**The Arcade, Dewsbury
& 18-20 Corporation Street / 17 Foundry Street**

Design and Heritage Statement Addendum

1705-BDP-AD-XX-RG-Z-00006

PROJECT NUMBER
P3001705
DRAWING TITLE
First Floor Removals Plan

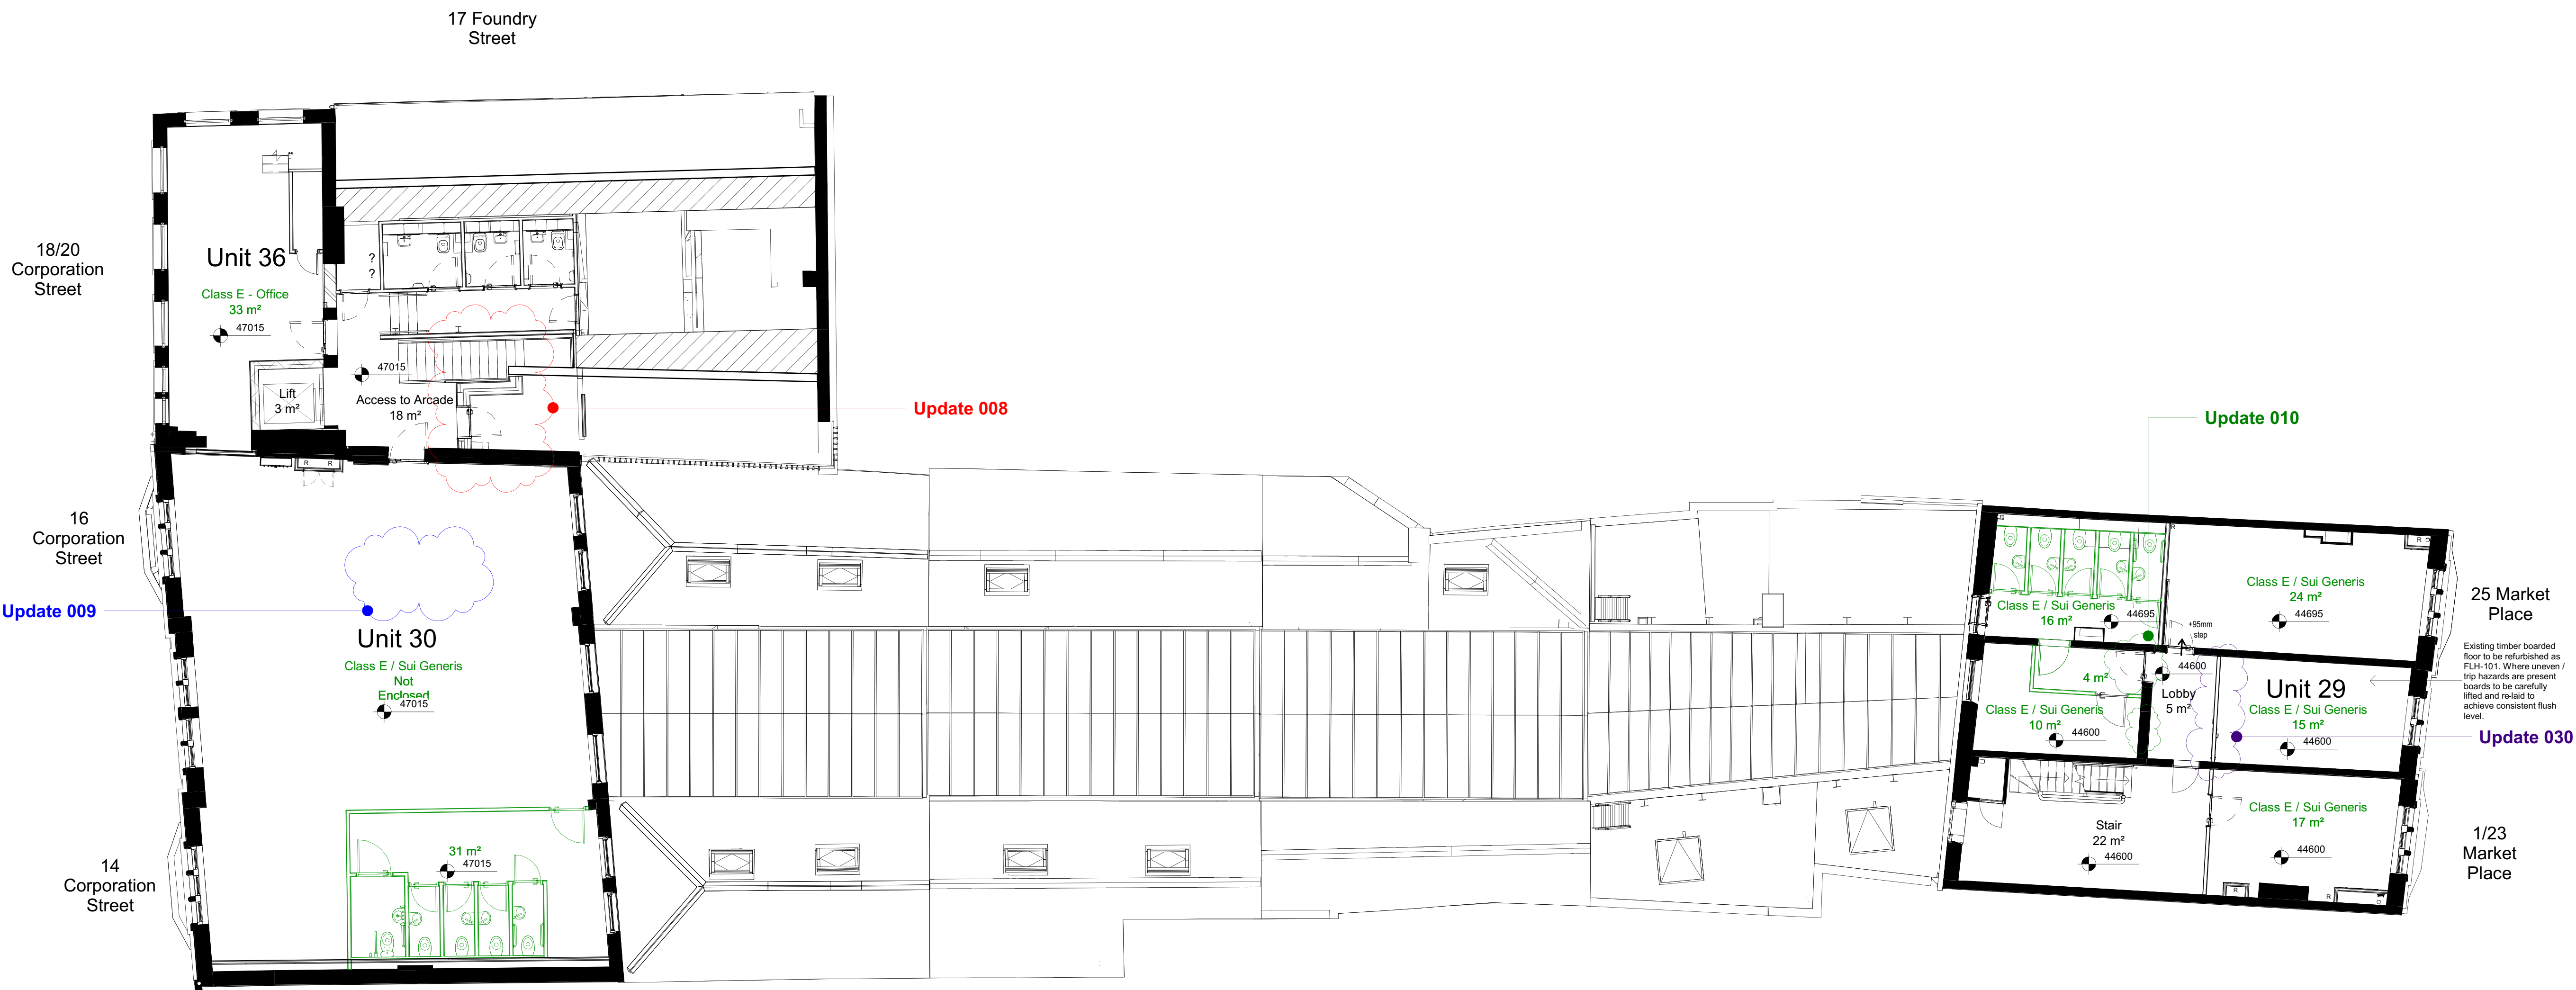
005	Central Arcade Units 9 and 17b	Internal partitions	Existing partitions were assumed to be historic lath and plaster partitions to be retained and upgraded to meet the new fire performance requirements for a 60-minute protected stairway where applicable.	Following on-site opening up, the partitions were found to be a mix of more modern construction and were generally poorly built incorporating hard board / MDF.	LIFE SAFETY + PERFORMANCE: These were not historic elements of the building with heritage value as evidenced by their absence on the historic plans in the West Yorkshire Archives, and it would not be practical to upgrade them to provide 60 minute fire resistance to support continued viable and flexible uses.	Replace these sections of partition with new plasterboard partitions to provide the required fire resistance. This is the same approach that had already had consent for the partitions forming the fire-protected stair in unit 18b on the opposite side of the arcade.	Negligible	1705-BDP-AD-01-PL-A-20001_T01 1705-BDP-AD-01-PL-A-20002_T01	1705-BDP-AD-01-PL-A-20001_T02 1705-BDP-AD-01-PL-A-20002_T02

006	18-20 Corporation Street and 17 Foundry Street Unit 34 / 35	Stairwell and door	No lobby to top of stair. New door to swing outwards.	n/a	LIFE SAFETY: For safe fire evacuation, it has been proposed that these units should be lobbied from the protected stair, and the door to unit 34 should swing into unit 34, to avoid impacting the escape route from unit 35 and support continued viable and flexible uses.	Minor change to internal layout with new lobby added. Door to swing inwards (into unit 34)	Negligible	1705-BDP-AD-01-PL-A-20001_T01 1705-BDP-18-ZZ-PL-A-00002_P06	1705-BDP-AD-01-PL-A-20001_T02 1705-BDP-18-ZZ-PL-A-00002_P07
007	Central Arcade First floor units	Floors	Units 17d, 18a, 18b, 18c and 18d: replace the floors due to wet and dry rot. Units 7a, 9, 10, 17a-c, 17e, 18d-f, 25, 26 and 35: Refurbish the floors: lift boards, strengthen and repair existing joist structure. Reinstall existing boards wherever practical and supplement with new.	Additional timber surveys have revealed extensive wet and dry rot had already been identified in units 17d, 18a, 18b, 18c and 18d, 25, 26 and 35. Further wet and dry rot was found in the remaining units affecting the joists and floorboards.	LIFE SAFETY + CONDITION: The existing joists were damaged by wet and dry rot to the extent that their condition was very bad and strengthening them was not practicable to support continued use. The floorboards were similarly damaged and in poor condition so that only short lengths could be recovered for reuse.	Replace the timber joist floor structure to the remaining units in the areas that have been affected by wet and dry rot (as had already been had consent for units 17d, 18a, 18b, 18c and 18d). Recover all lengths of floorboard which are suitable for reuse and install them in units 7a and 9, with new floorboards to matching profiles used elsewhere. This will allow two units to retain and evidence the appearance of their original floor.	Minor Adverse	1705-BDP-AD-01-PL-A-20002_T01	1705-BDP-AD-01-PL-A-20002_T02

Update 007

DRAWING TITLE
Roof GA plan as proposed

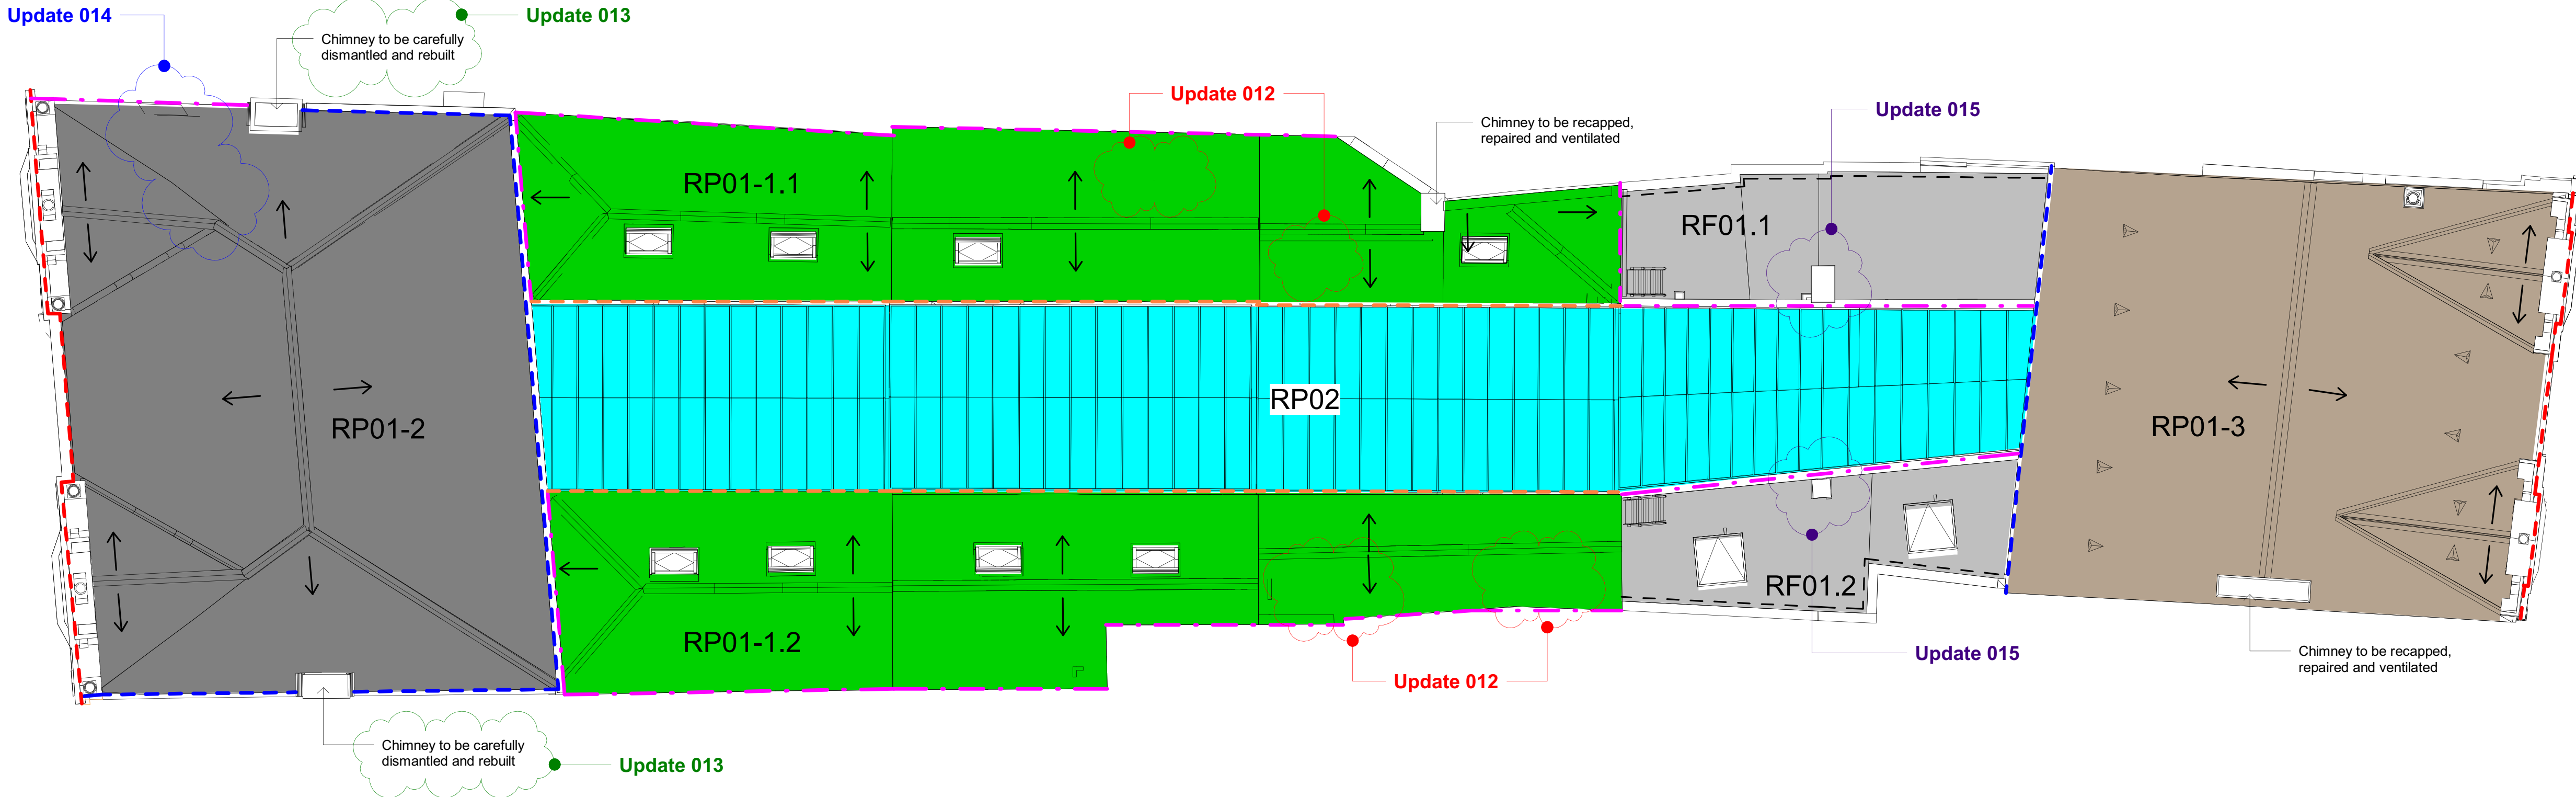
012	Central Arcade First floor units	Rooflights	Remove existing rooflights and install a new secure rooflight to each first floor unit in the central arcade area.	Following further on-site investigations, the spacing between the existing purlins varies.	PERFORMANCE: The purlin spacing in 4no. of the units is too close to allow a modern secure rooflight to be installed.	Omit 4no. rooflights to units 7a, 9, 18e and 18f. The remaining 6no. rooflights to the other units in this area will still be installed.	Negligible	1705-BDP-AD-RF-PL-A-20005_P01	1705-BDP-AD-RF-PL-A-27001_P02
013	14-16 Corporation Street	Chimneys	The two chimneys were intended to be repointed and recapped.	Following a fingertip survey of the existing, these chimneys were found to be in a poor condition, with suspected sulphate attack to the masonry, causing leaning.	LIFE SAFETY + CONDITION: Leaving the chimneys in this poor condition would pose a safety risk. They would potentially also be a weak point for further moisture to enter the building, and are not easily accessible for ongoing repairs.	Carefully dismantle and rebuild the chimneys straight and plumb, reusing the existing stone wherever possible and supplementing with new to match unit sizes and profiles.	Negligible	1705-BDP-AD-RF-PL-A-20005_P01 1705-BDP-AD-XX-EL-A-20001_P01 1705-BDP-AD-XX-SE-A-20001_P01	1705-BDP-AD-RF-PL-A-27001_P02 1705-BDP-AD-XX-EL-A-20001_T02 1705-BDP-AD-XX-SE-A-20001_T02

014	14-16 Corporation Street	Rooftop walkway	A covered rooftop walkway had been added to connect this roof storage deck to the third floor of 18-20 Corporation Street. This was shown as remaining in location.	Following further on-site investigations, this walkway was found to be built using modern materials and was in a poor condition.	ENHANCEMENT: Opportunity to remove an inappropriate modern addition in poor condition and return the profile of the roof to its original state. This is also on the principal elevation of the building, facing onto Corporation Street.	Carefully remove the modern walkway and continue the form of the original slate roof covering over this area of the roof.	Moderate Beneficial	1705-BDP-AD-RF-PL-A-20005_P01	1705-BDP-AD-RF-PL-A-27001_P02
015	Central Arcade Units 3-6	Brick piers over these units	These brick piers were previously assumed to be chimneys which were to be ventilated and recapped.	On close inspection, these have been found to be piers reinforcing the external brick walls at first floor level	n/a	No ventilation or recapping is required, works omitted.	Neutral	1705-BDP-AD-RF-PL-A-20005_P01	1705-BDP-AD-RF-PL-A-27001_P02

023	17 Foundry Street	Stairwell	A new store was included at the end of the second floor space at the head of the stairwell.	n/a	LIFE SAFETY: For safe fire evacuation, it has been proposed that the store room should be omitted.	Omit this store room.	Neutral	1705-BDP-18-ZZ-PL-A-00002_P06	1705-BDP-18-ZZ-PL-A-00002_P07
024	18-20 Corporation Street Units 35 and 36	Floor coverings	Retain existing floor coverings	These modern floor coverings were found to be Asbestos-Containing Materials (ACMs).	LIFE SAFETY: ACMs pose a health risk to the proposed works when they could be disturbed during the refurbishment, and as an ongoing residual risk when they could be disturbed unknowingly for example by future tenants.	Remove these floor coverings to expose floorboards.	Neutral	1705-BDP-18-ZZ-PL-A-00002_P06	1705-BDP-18-ZZ-PL-A-00002_P07
025	Central Arcade	Glazed roof structure	Timber ridge beams, wall plates and principal rafters to be redecorated.	Additional timber surveys have revealed extensive wet rot to end bearings of ridge beams and principal rafters and wet rot to exposed faces of wall plates.	LIFE SAFETY + CONDITION: The structural engineer confirmed the existing timber structure could not continue to sustain the required loading performance resulting in future failure preventing continued viable and flexible uses Arcade-wide.	Replace the timber with new where decayed, using the same profiles, and decorate to match the existing.	Minor Adverse	1705-BDP-AD-RF-PL-A-20005_P01	1705-BDP-AD-RF-PL-A-27001_P02

Section BB

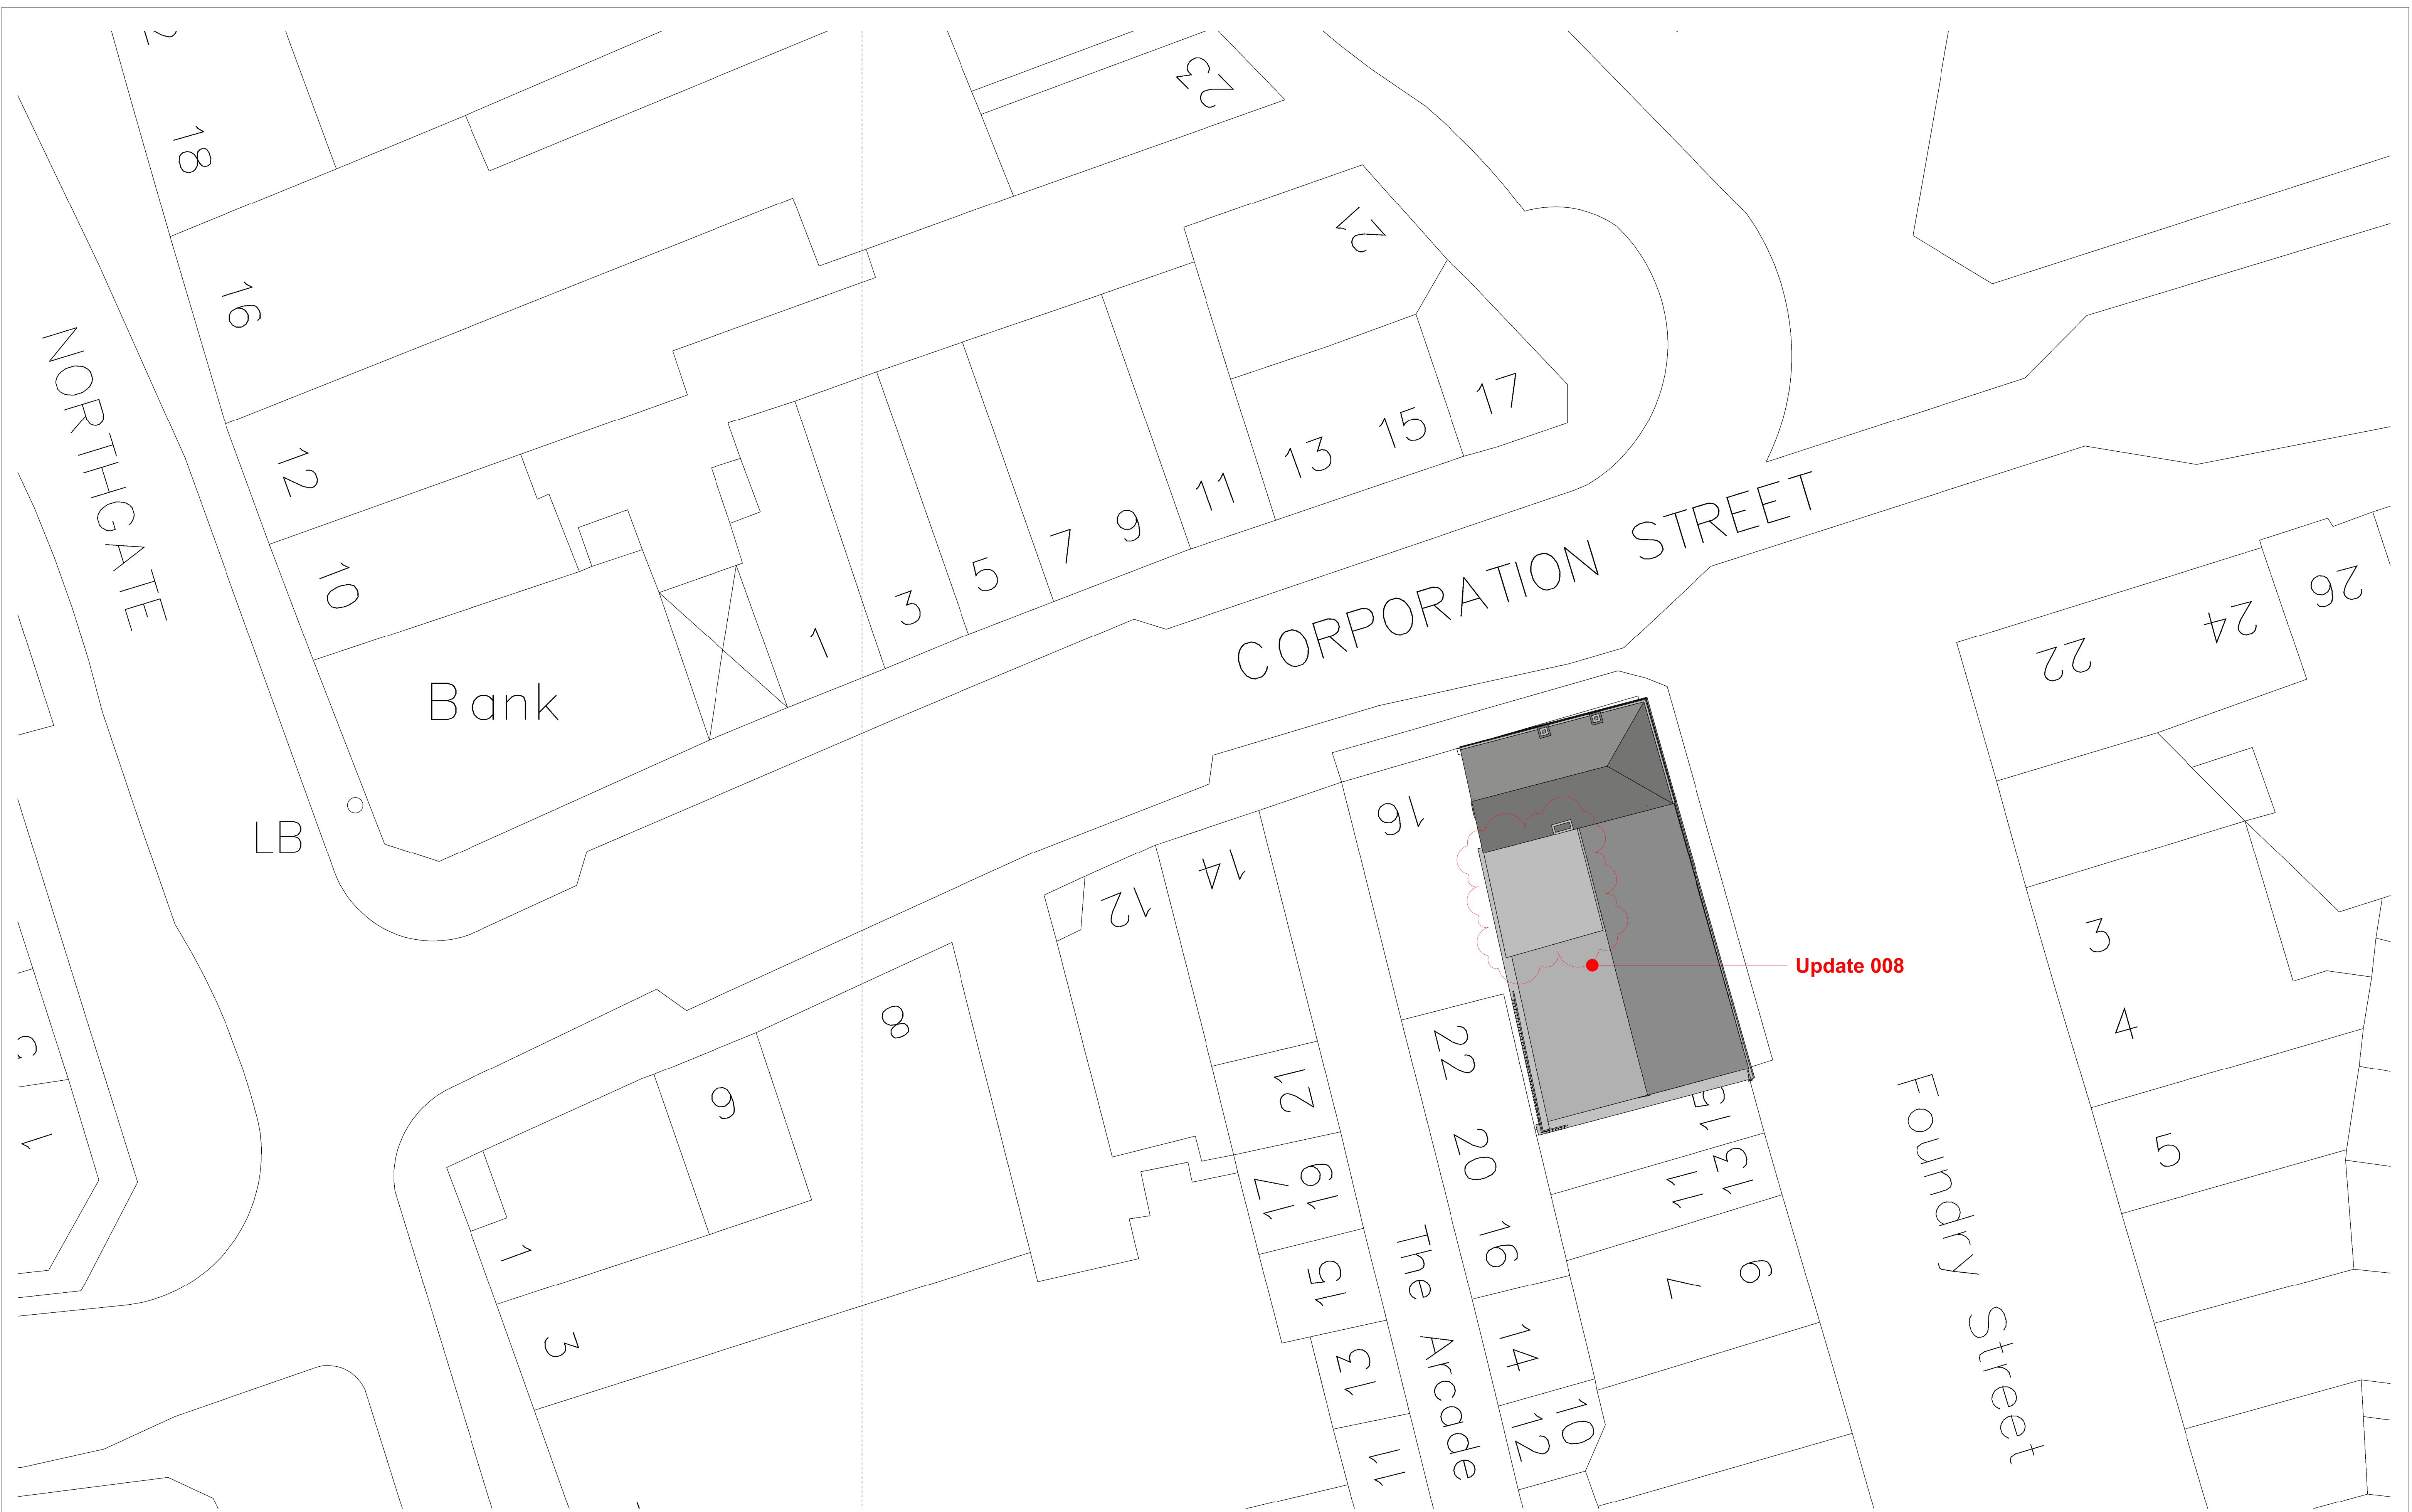
021	23-25 Market Place Rear elevation of Market Place building	Gutter and rainwater pipe	Replace the existing cast iron gutter and rainwater pipe in the same size, profile and material.	Rainwater falling on the rear pitch of the Market Place roof falls into valley gutters and the eaves gutter, then into a single rainwater pipe which discharges into the glazed roof gutter, which transports rainwater back towards Corporation Street, into another rainwater pipe, onto the top of a slate roof, into another gutter, into an outlet, and then into an internal rainwater pipe.	PERFORMANCE: This route is extremely convoluted, and has multiple junctions. There is evidence of past leaks in some areas below. A single rainwater pipe for this large area of roof provides no secondary resilience. It also seems unlikely that this was the original route for rainwater discharge.	Remove the existing single rainwater pipe, provide new cast iron rainwater pipes (to match existing profile) at both ends of this gutter discharging directly to the flat roof drainage.	Negligible	1705-BDP-AD-XX-SE-A-20002_P01	1705-BDP-AD-XX-SE-A-20002_T02

022	Central Arcade, 14-16 Corporation Street and 18-20 Corporation Street Refer to elevation drawings	Windows	Repair windows where possible using traditional techniques. Some windows were known to have extensive wet or dry rot, or were absent and were therefore proposed to be replaced.	Additional windows were found to have extensive wet and dry rot. (2 to 14 Corporation Street North Elevation, 2 to Central Arcade East Elevation, and 2 to Central Arcade West Elevation, 3 to 18-20 Corporation Street North Elevation)	CONDITION: These additional windows are so extensively decayed to the extent that they are in very bad condition and unsuitable for repair.	Replace 6 no. windows, in addition to the 3 no. already proposed to be replaced (in unit 30, shown on Section AA). Replacement windows to match existing in size, proportions and timber profiles.	Negligible	1705-BDP-AD-XX-EL-A-20001_P01 1705-BDP-AD-XX-EL-A-20005_T01 1705-BDP-AD-XX-EL-A-20004_P01 1705-BDP-AD-XX-SE-A-20002_P01 1705-BDP-18-ZZ-EL-A-00002_P04	1705-BDP-AD-XX-EL-A-20001_T02 1705-BDP-AD-XX-EL-A-20003_T02 1705-BDP-AD-XX-EL-A-20004_T02 1705-BDP-AD-XX-SE-A-20002_T02 1705-BDP-18-ZZ-EL-A-00002_P05
